AN EVALUATION OF HIGH-TEMPERATURE GAS-COOLED REACTORS

December 1969

OAK RIDGE NATIONAL LABORATORY

5. ENGINEERING REVIEW OF PLANT DESIGN

Fig. 5.2. Fuel-Handling Machine for Backup Design. (GGA illustration)

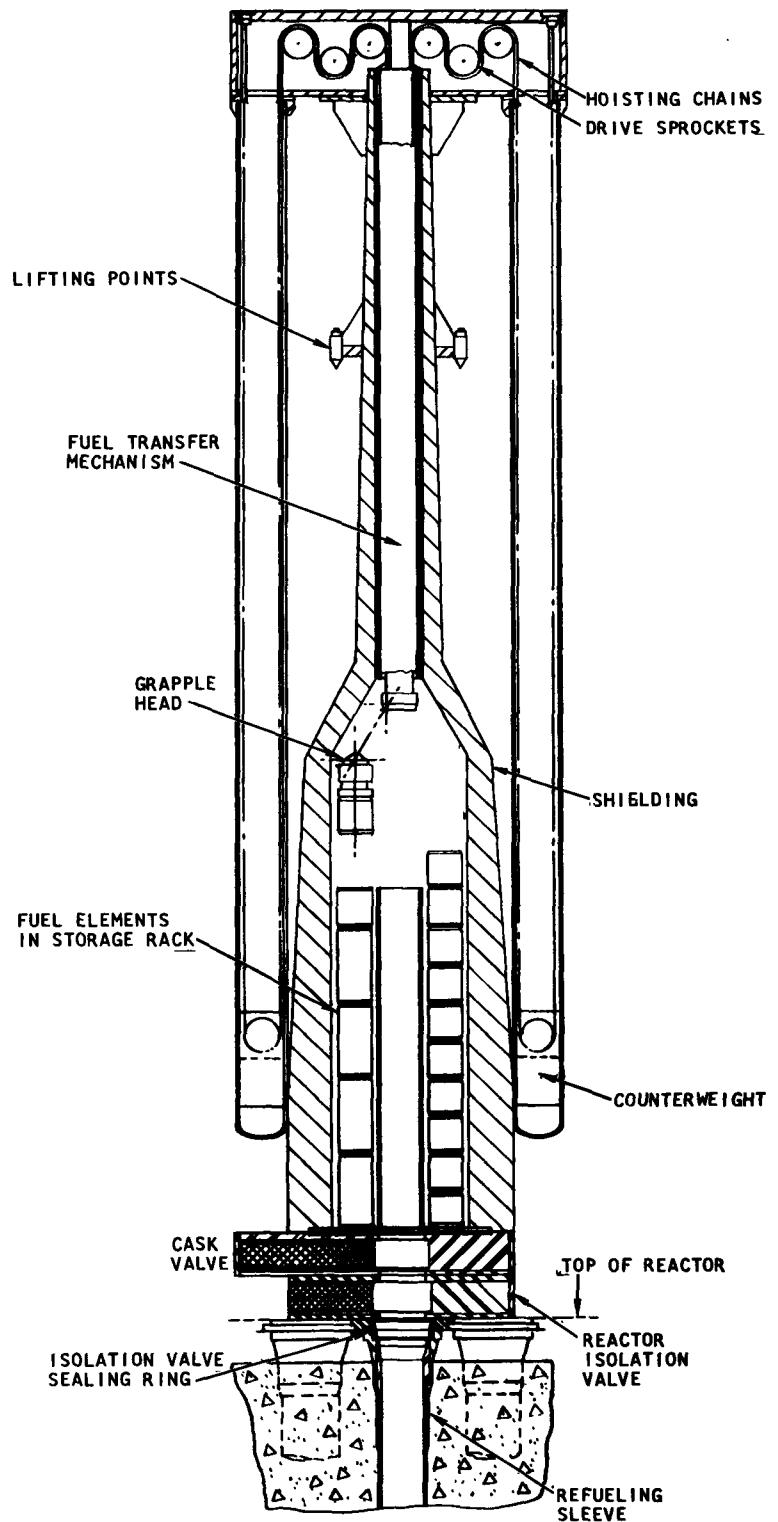
As presently designed, the fuel elements have sufficient tolerance accumulation for interference to develop at the interface between two fuel elements. It appears that this problem can easily be eliminated at little or no increase in fabrication cost by changing the dowel design to allow it to be located on a shoulder rather than a threaded surface. The fuel element drawing is shown in Fig. 2.1. Reflector blocks are essentially the same shape as the fuel blocks but consist only of graphite.

Fig. 5.8. Heat Balance Diagram for Backup Design. (GGA illustration)

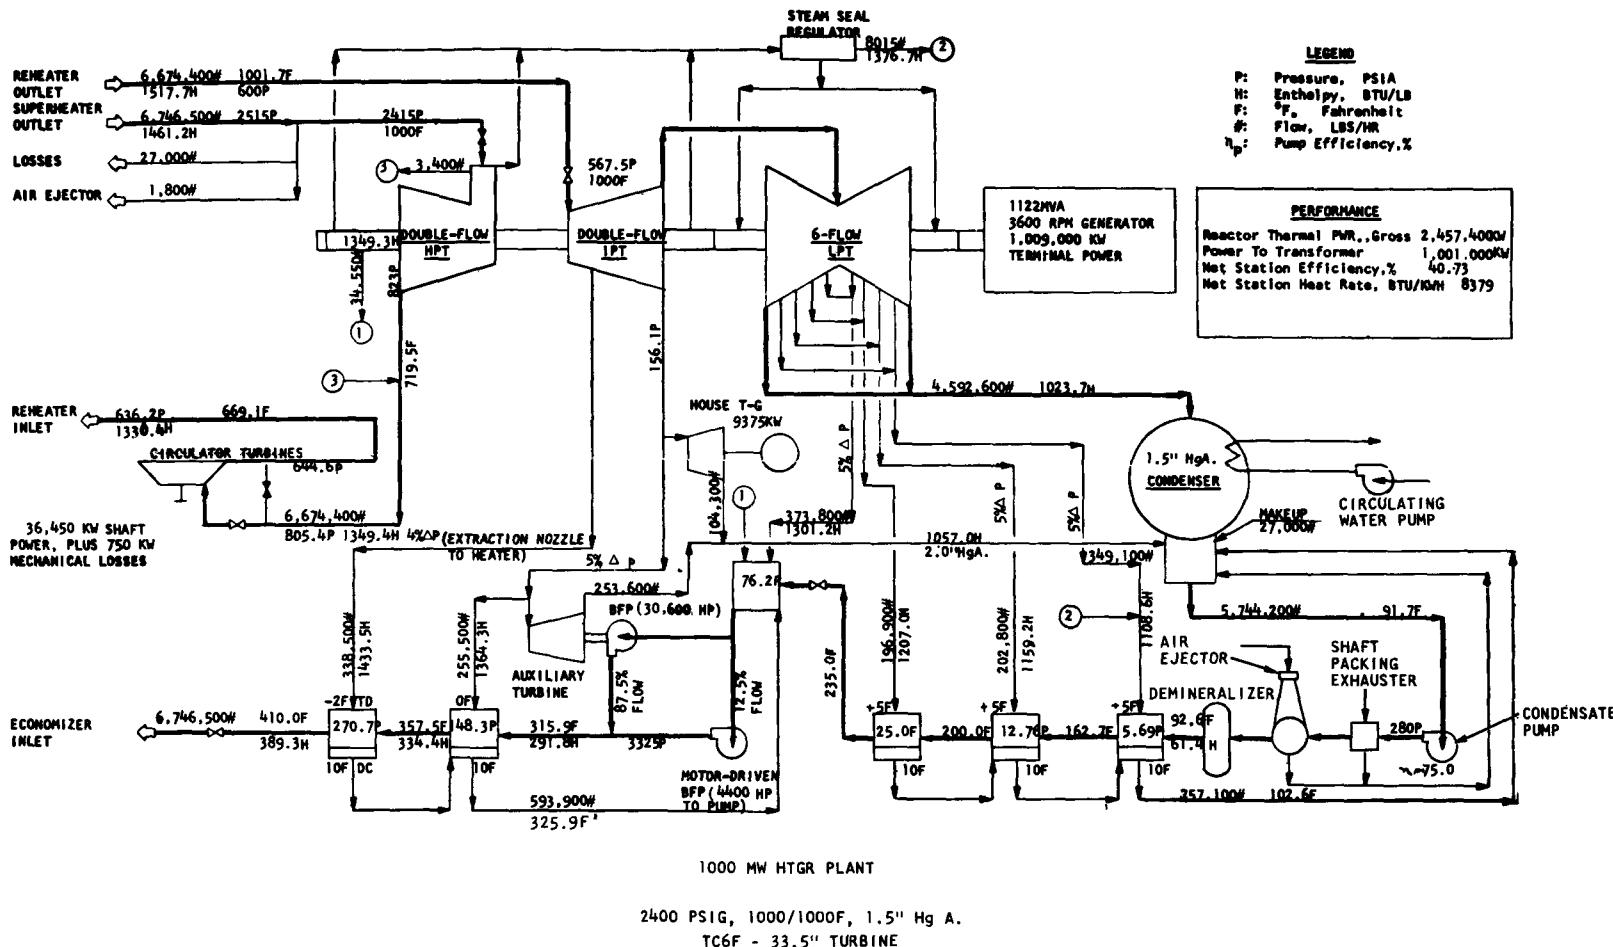
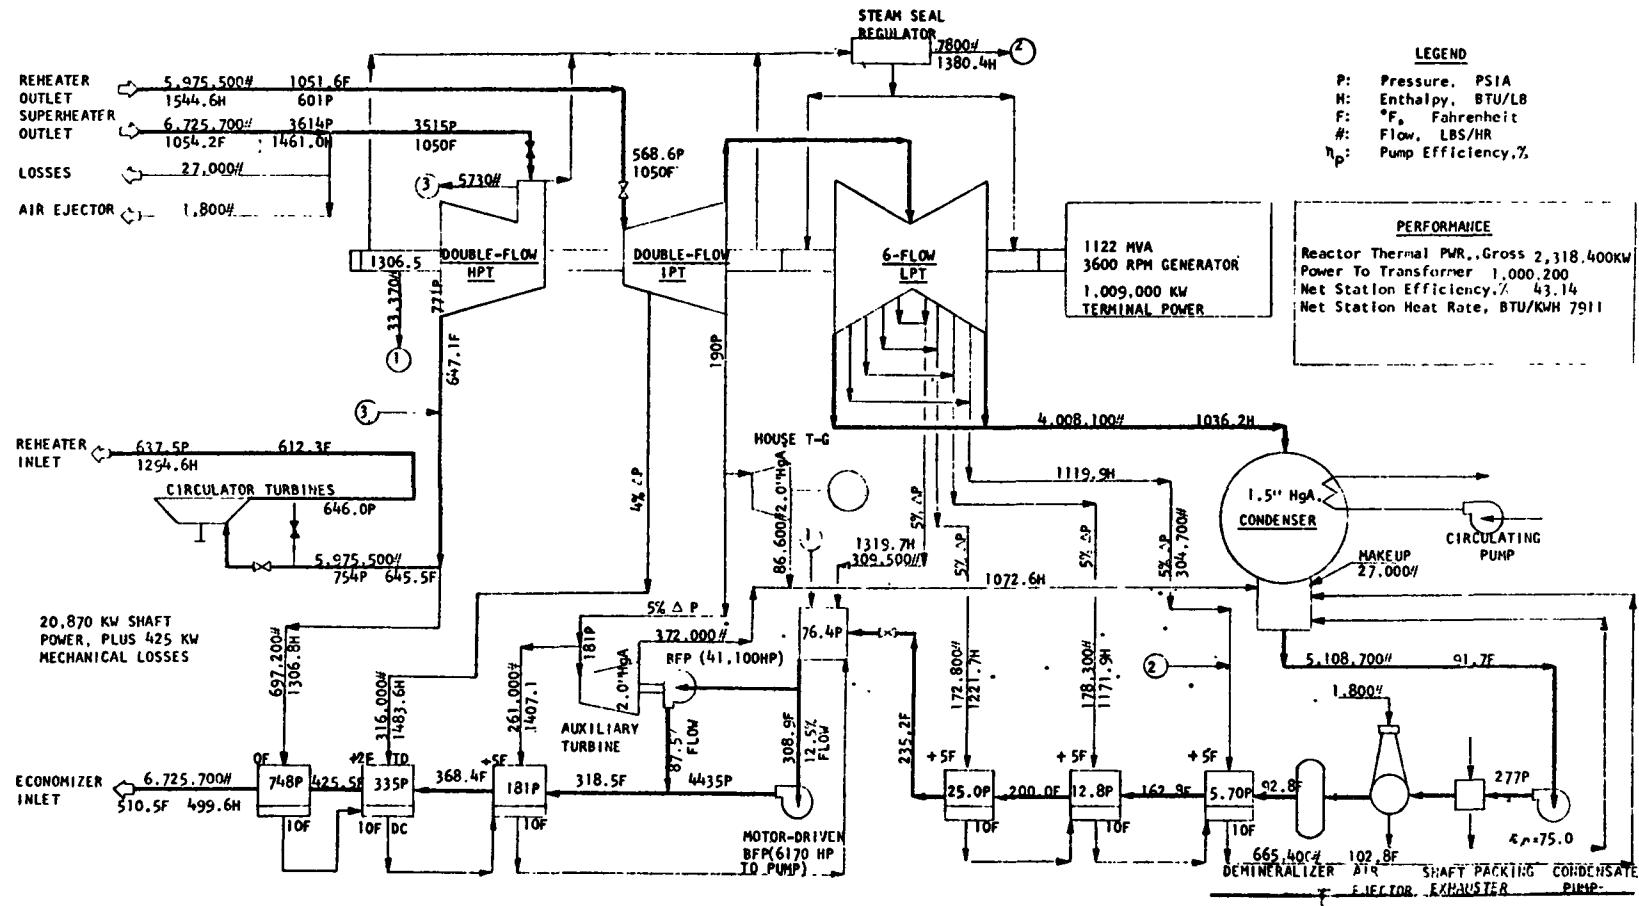
The heat balances shown in Figs. 5.8 and 5.9 were evaluated and found to be correct to within a fraction of 1%. The net station heat rates of 8379 and 7911 Btu/kwhr for the backup and reference designs, respectively, were confirmed.

Fig. 5.14. Turbine Plant Arrangement, Operating Floor. (GGA illustration)

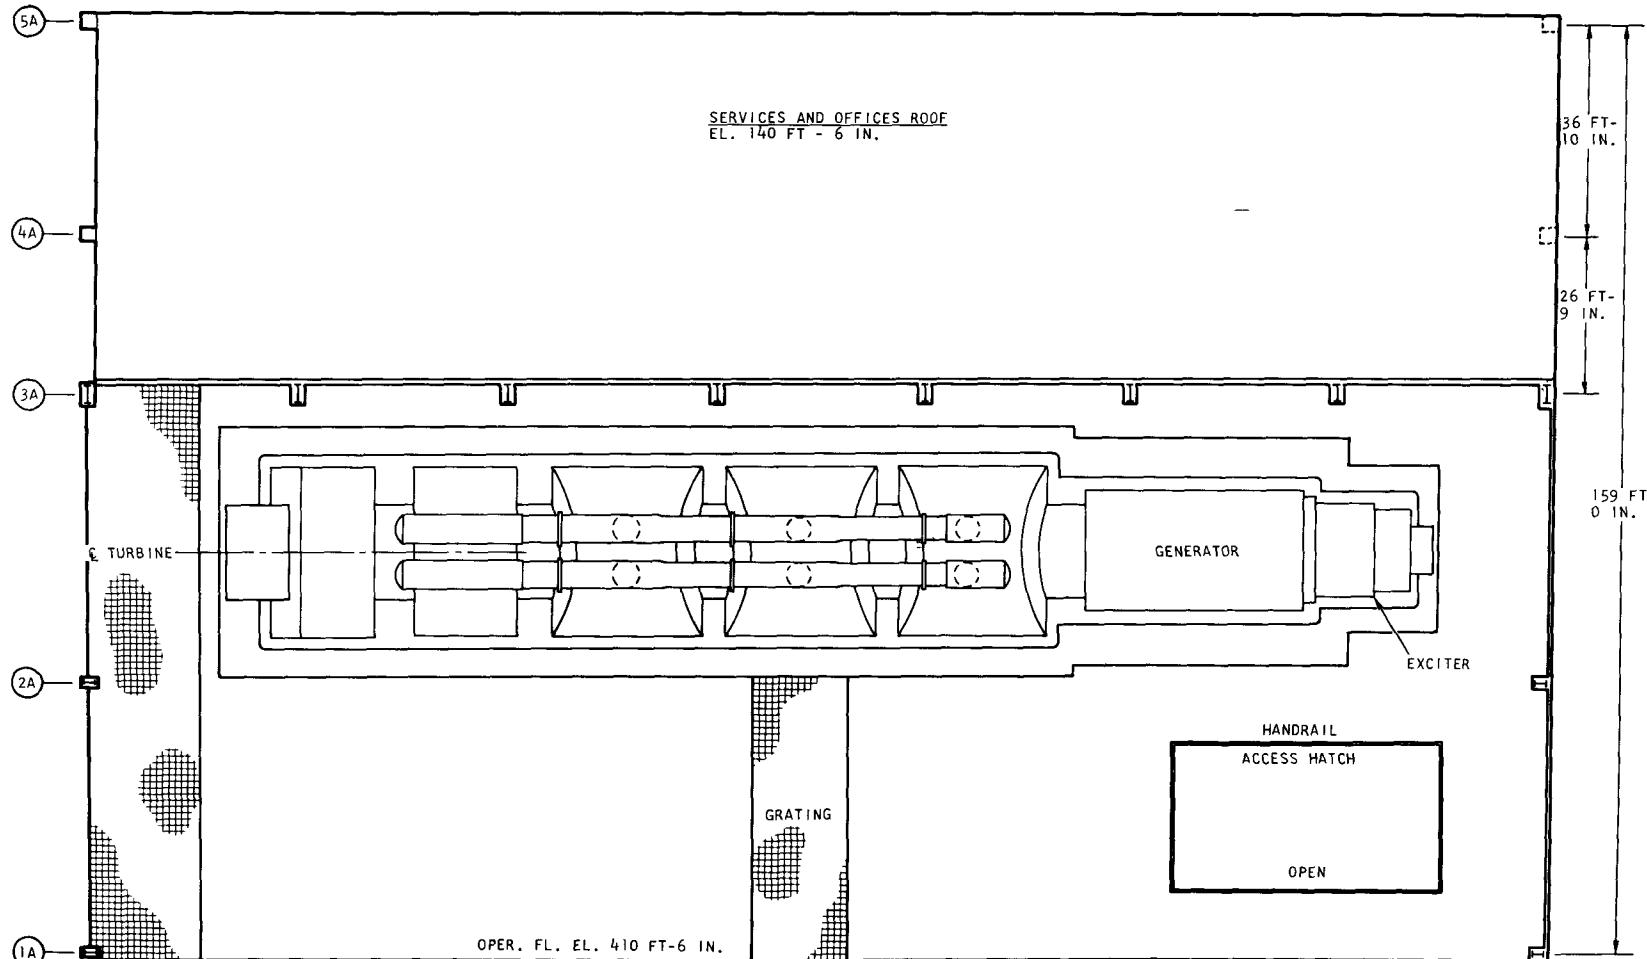
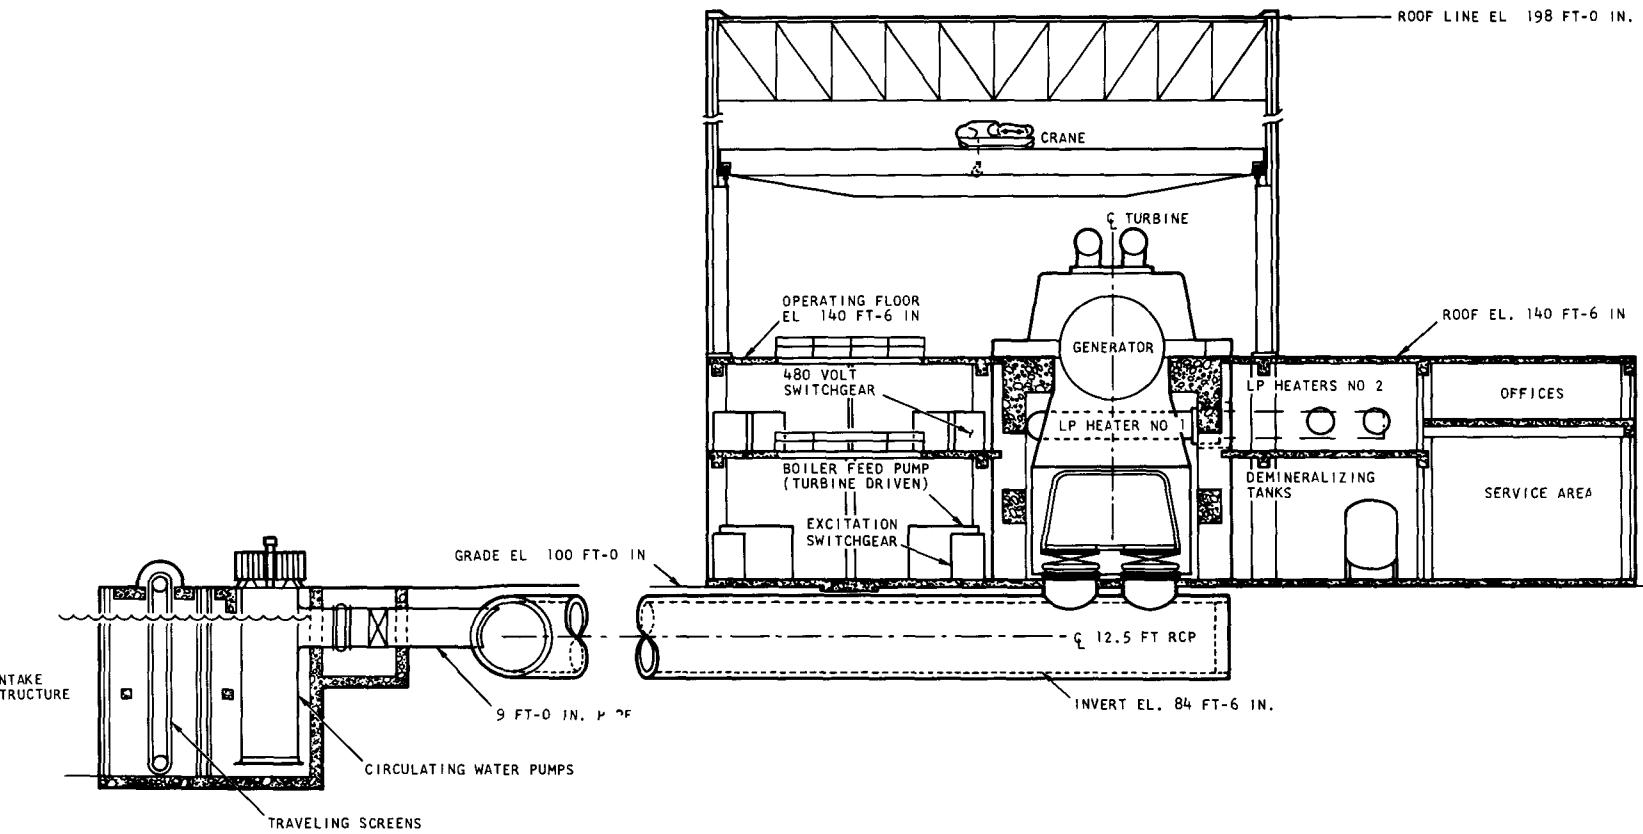
Turbine building arrangements indicate a sufficient amount of lay-down area. Assuming simultaneous overhaul of all sections of the turbine and removal of the generator, it will be necessary to remove the casings from the turbine building. The space provided is comparable to that of other concepts being evaluated.
